UNITED STATES PATENT AND TRADEMARK OFFICE

Office Action Summary	Application No. 09/876,396	Applicant(s) KARIYAZAKI, SYUUICHI	
	Examiner Colleen A. Matthews	Art Unit 2811

DETAILED ACTION

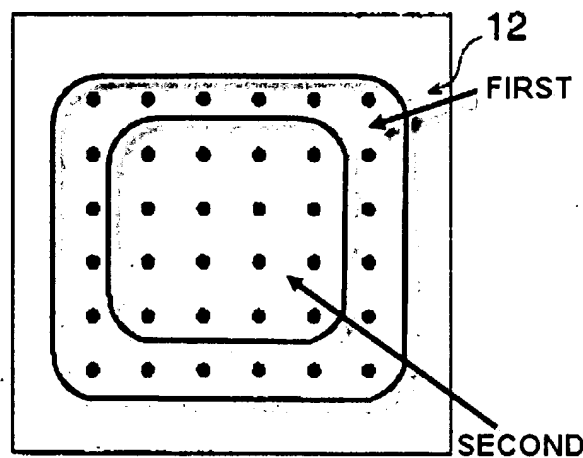
Regarding claim 1, Stager et al. teach a semiconductor device (Figs. 1 & 2, for example) comprising: a semiconductor member (14) having thereon a plurality of electrode terminals; and a mounting member having a plurality of interconnect pads (12) electrically and mechanically connected to the respective electrode terminals for mounting the semiconductor member on the mounting member; and the interconnect pads forming a plurality of I/O cells including signal terminals, (Col. 3, lines 47 - 57), a

portion of the I/O cells forming a first group (FIRST, see annotated figure below) of I/O cells and another portion of the I/O cells forming a second group (SECOND, see annotated figure below) of I/O cells on an inner position of the mounting member with respect to the first group of I/O cells.
